LAND NORTH OF ARBORFIELD ROAD, SHINFIELD
DESIGNER'S RESPONSE

BELLWAY HOMES LTD (THAMES VALLEY)
05 February 2026

Prepared by:	E Hine
Authorised by:	A Golding
Date:	05 February 2026
Document Reference:	HD008-R005/A

Stage:	2
Location:	Land North of Arborfield Road, Shinfield, Berkshire
Site:	Proposed residential development and right-turn lane access
ATSS Ref:	251206
Client Ref:	HD008
Date:	28 January 2026

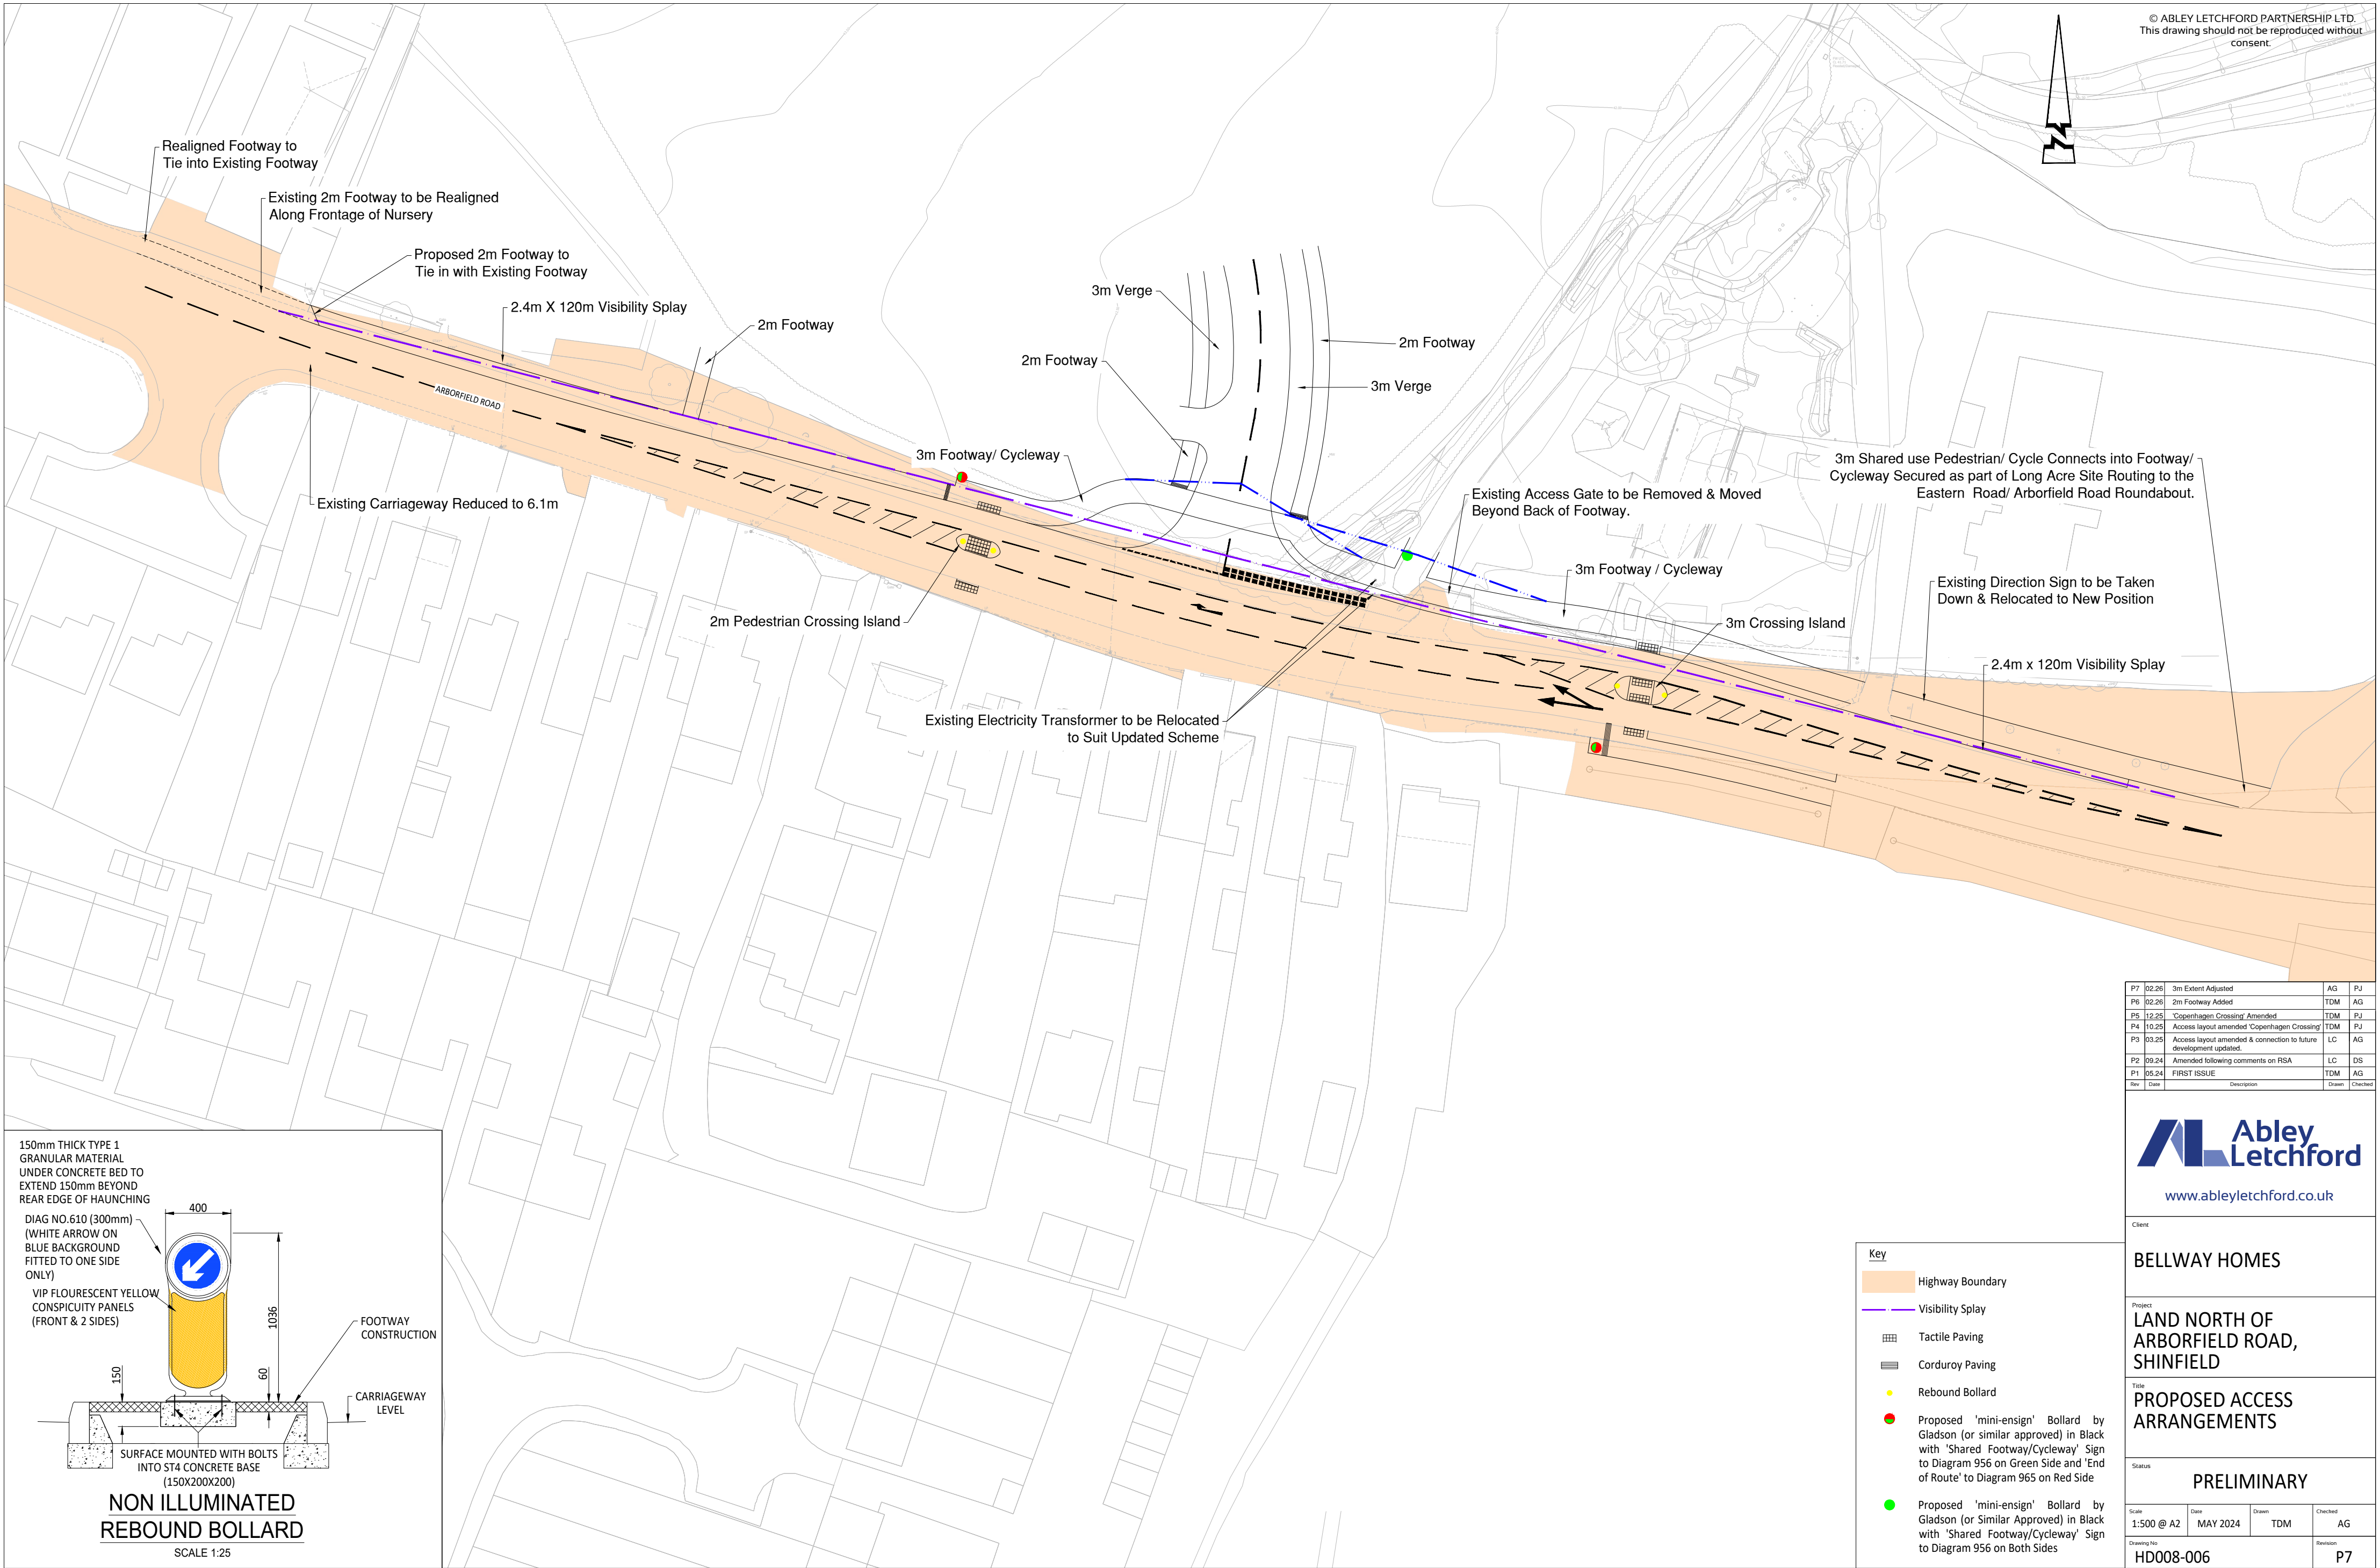
Location – North side of Arborfield Road at western end of scheme

The new footway on the north side of Arborfield Road appears to terminate approximately 45 metres short of the existing footway further to the west on this side. Pedestrians will be tempted to walk in the carriageway between the two footways, where they will be at risk of being struck by passing vehicles

Recommendation – Continue the footway westward to link with the existing footway

- 2.7.5 Agreed - A new 2m footway is proposed on the northern side of Arborfield Road to connect with the existing footway provision to the west as depicted on the revised Access Drawing HD008-006-P7 at **Appendix C**.
